BID
ADDENDUM #03

FOR THE
RENOVATION TO MAIN
TELECOMMUNICATIONS
ROOM

AT
WEST VALLEY COLLEGE

Bid #2-1415

Revision
SKE-04 Addendum C

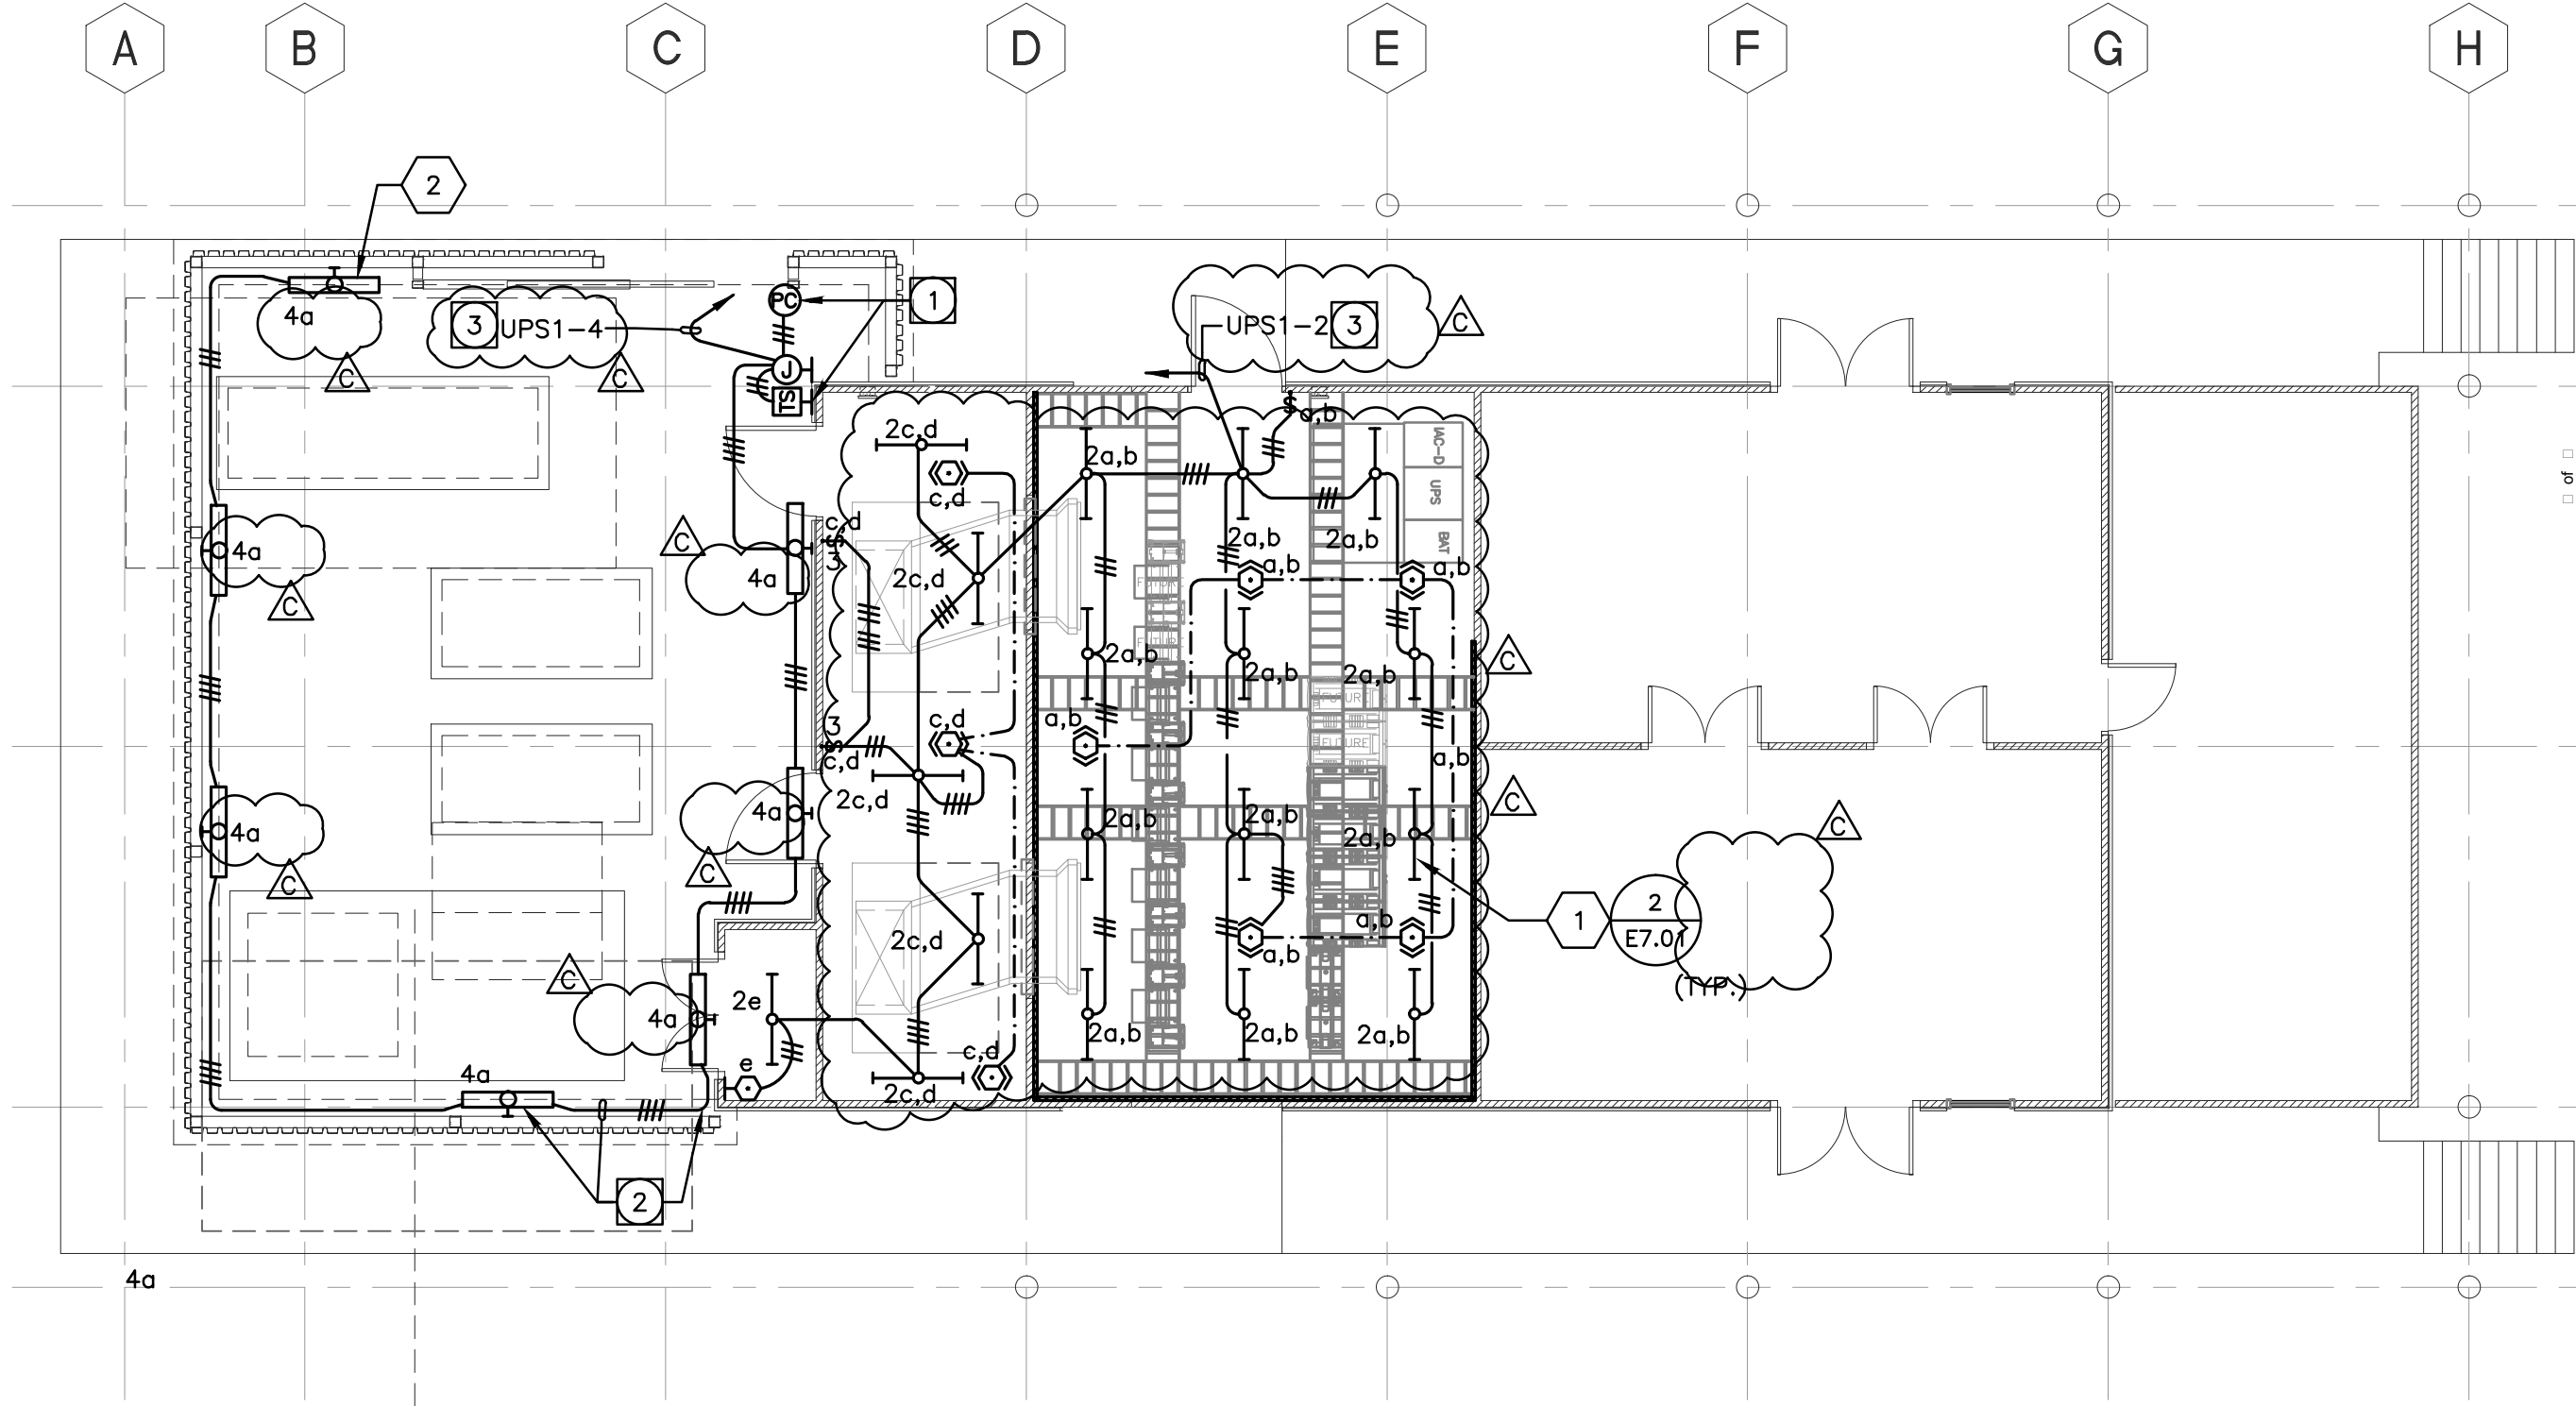
- ITEM NO. 11** Sketch revision SKE-04 of E2.01. Revised lighting circuiting and occupancy sensor layouts.
- ITEM NO. 12** Sketch revision SKE-05 of E3.01. Added plan note 3.

Revision
SKE-06
Addendum C

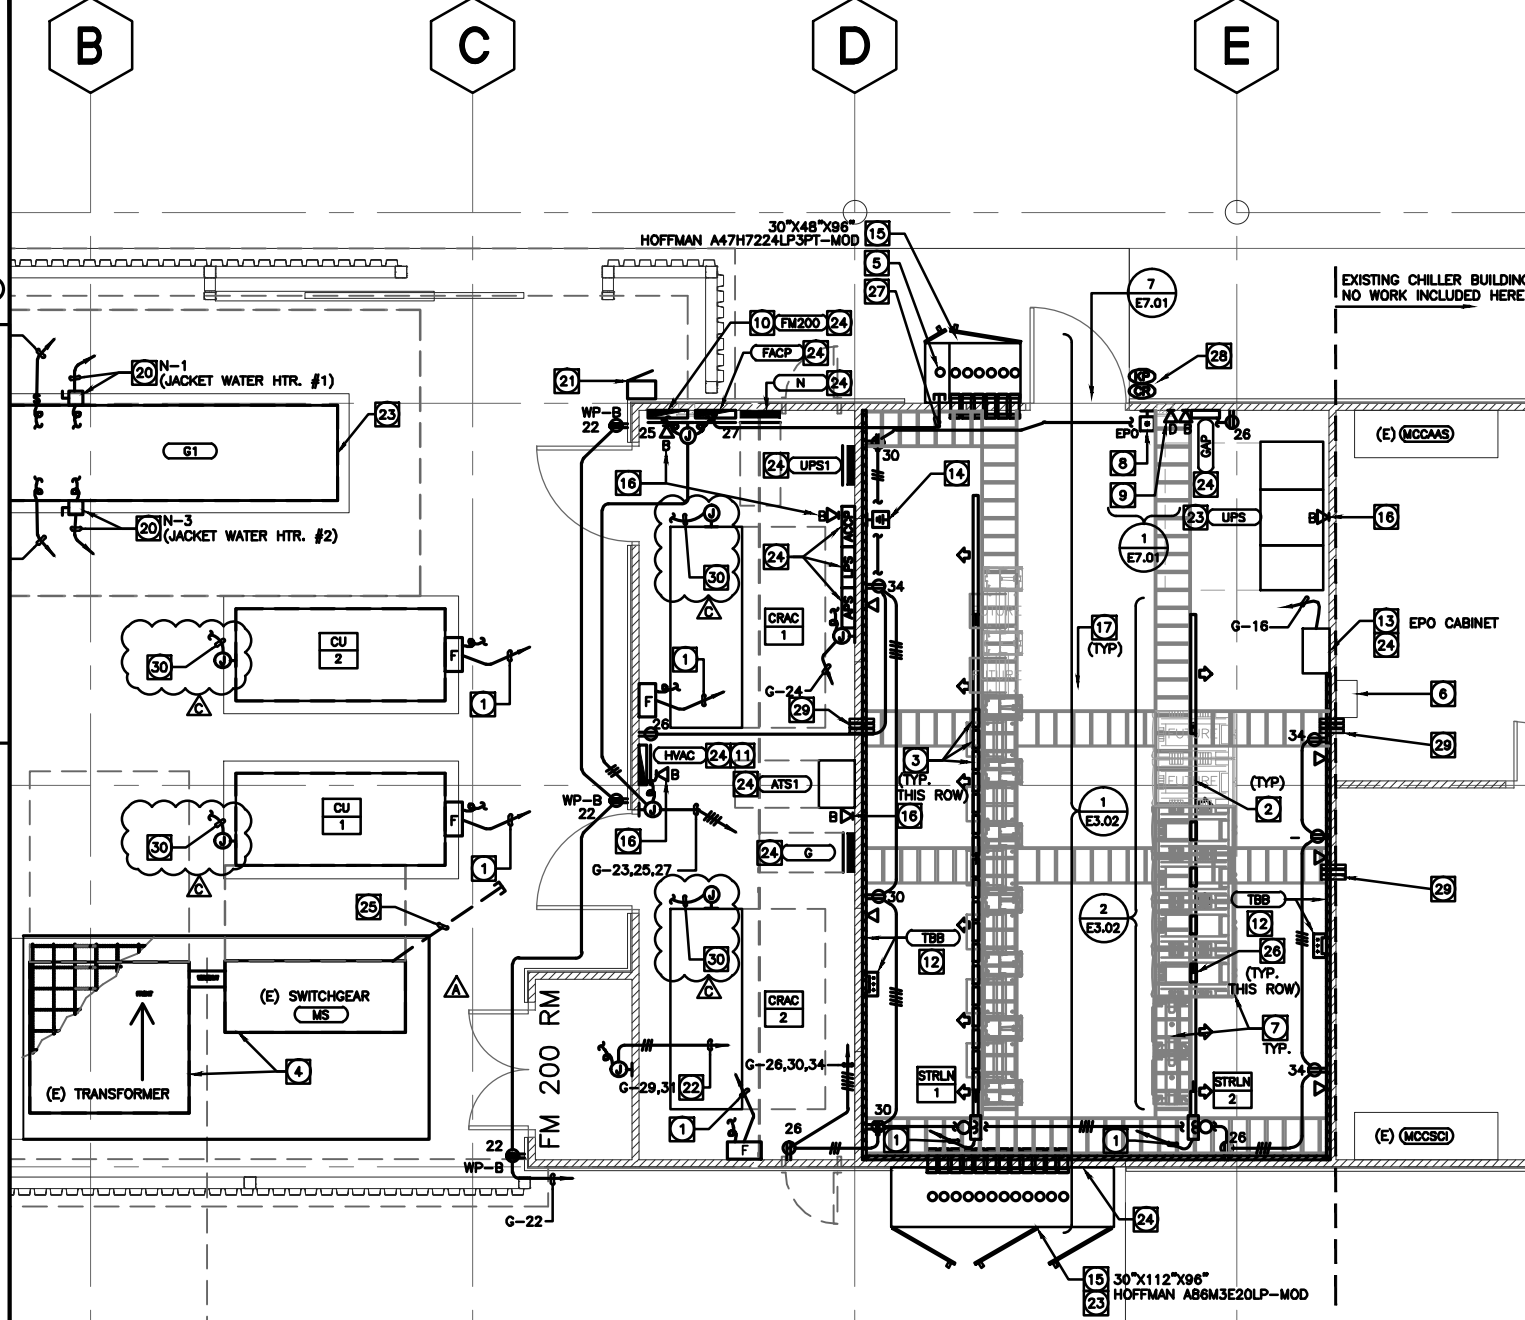
- ITEM NO. 13** Sketch revision SKE-06 of E3.01. Revised power plan and associated notes addressing district comments and HVAC control.
- ITEM NO. 14** Sketch revision SKE-07 of E3.01. Added motorized equipment schedule notes.

3 ~~PLUG-IN CIRCUIT BREAKER RECEPTACLE ENCLOSURES WITH 6' DROP CORDS.~~
REFER TO BUSWAY SCHEDULE AT SHEET E4.01 PLUG IN UNIT REQUIREMENTS.

26 ~~PLUG-IN CIRCUIT BREAKER RECEPTACLE ENCLOSURE.~~ REFER TO BUSWAY
SCHEDULE AT SHEET E4.01 PLUG IN UNIT REQUIREMENTS.

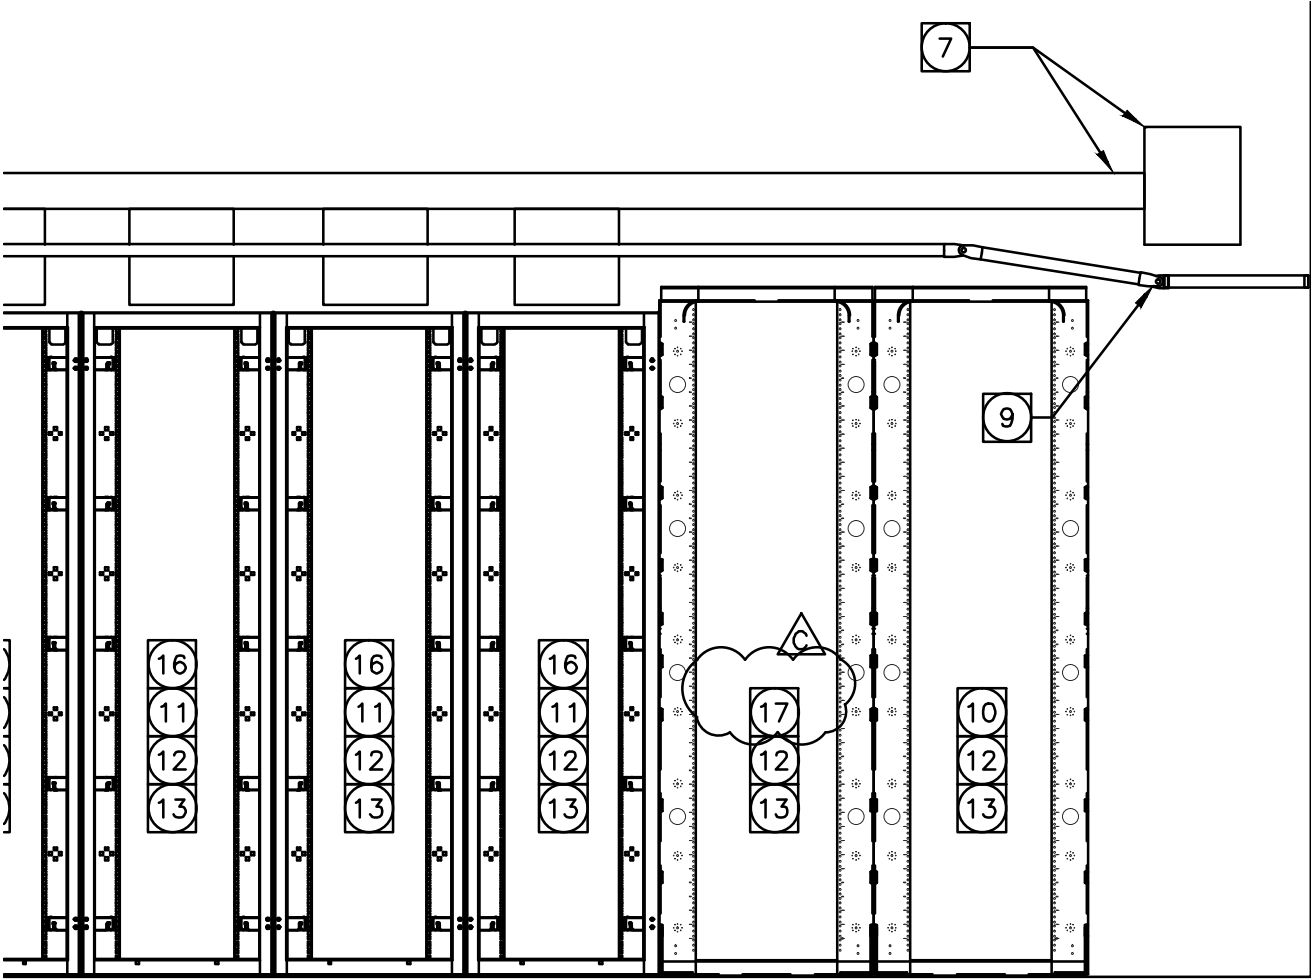
- ITEM NO. 15** Sketch revision SKE-08 of E3.02. Added plan note 17.
- ITEM NO. 16** Sketch revision SKE-09 of E4.01. Revised busway schedule model numbers.

17 U.L LISTED 23" RACK WITH 6" DEEP MOUNTING CHANNELS (CHATSWORTH #66383-713).

Sketch	Revision
Job No. 13122.10	SKE-13
Reference E6.02	Addendum C
Date 2/4/15	
Scale NTS

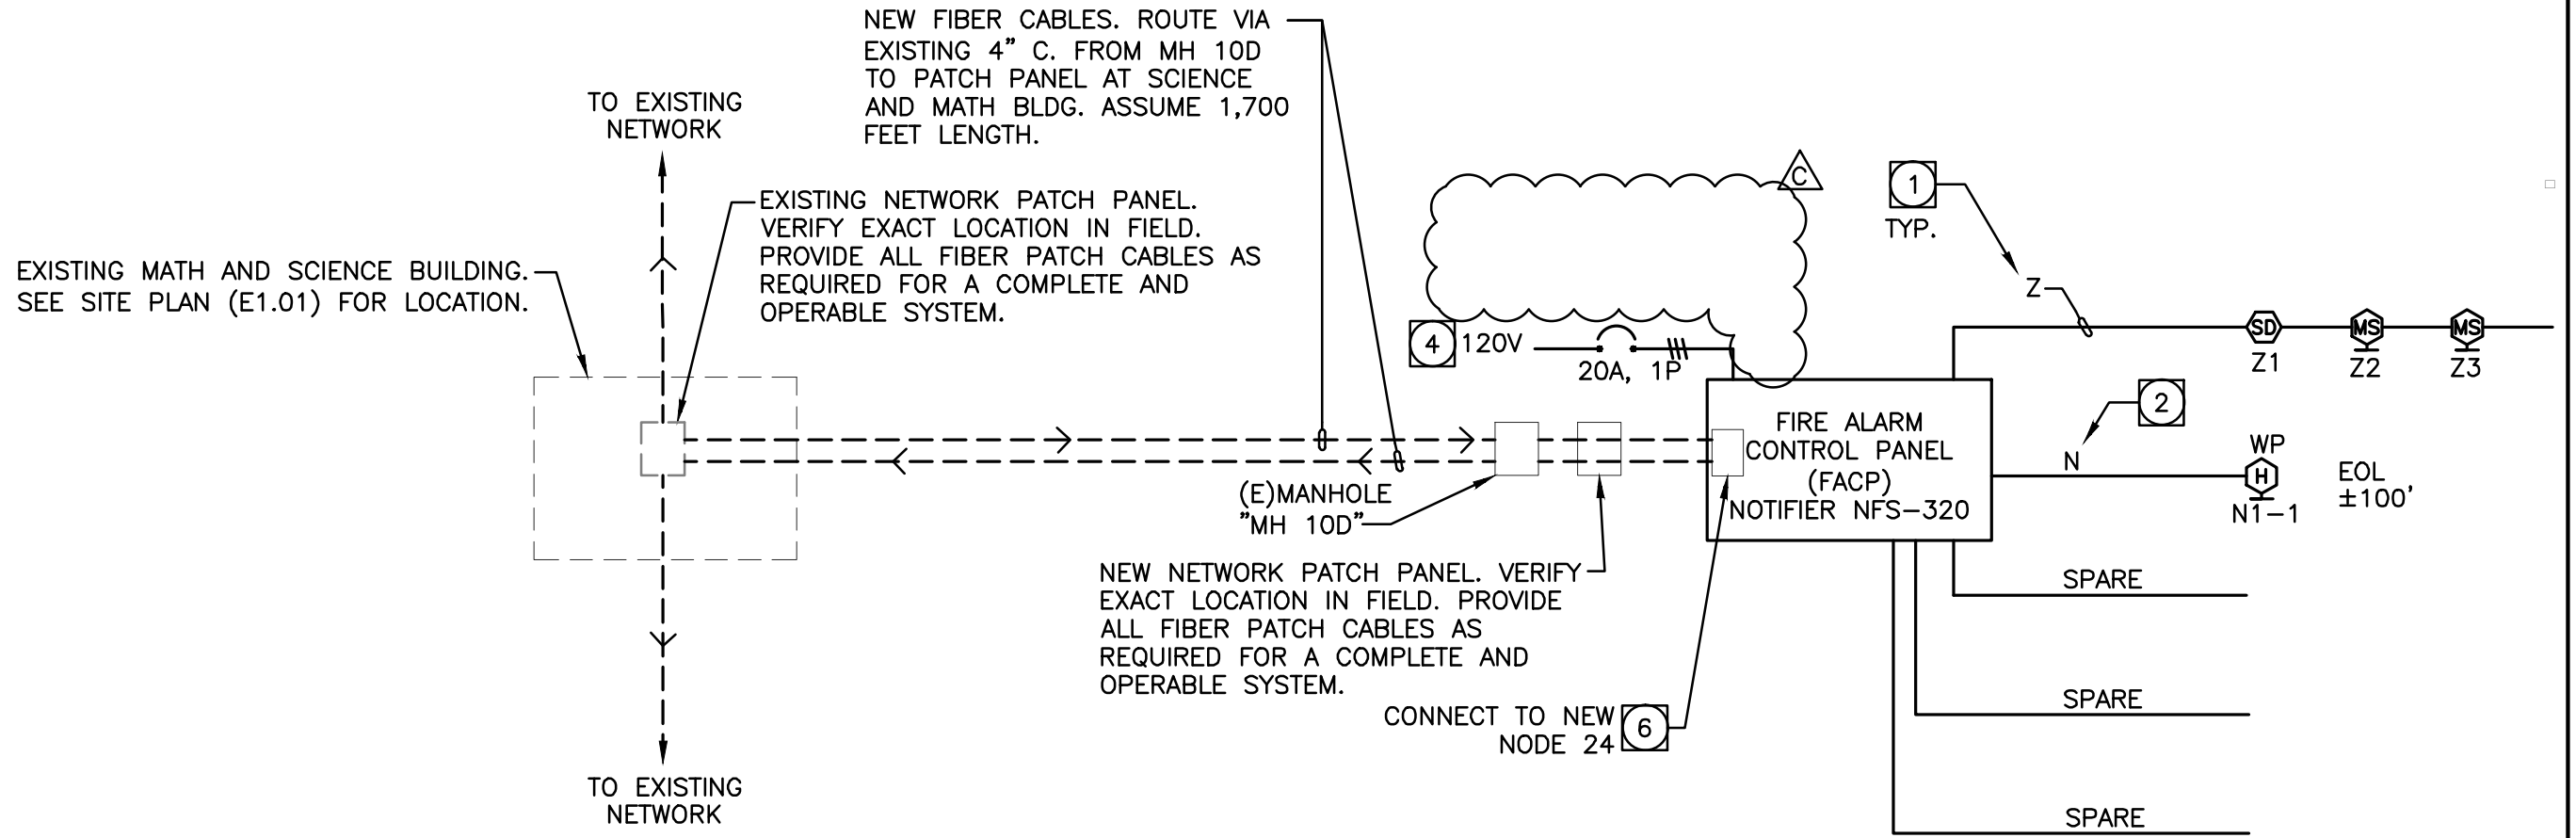
- ITEM NO. 20** Sketch revision SKE-13 of E6.02. Removed analog line and dialer from fire alarm riser.
- ITEM NO. 21** Sketch revision SKE-14 of T4.01. Revised fiber patch cable quantity.
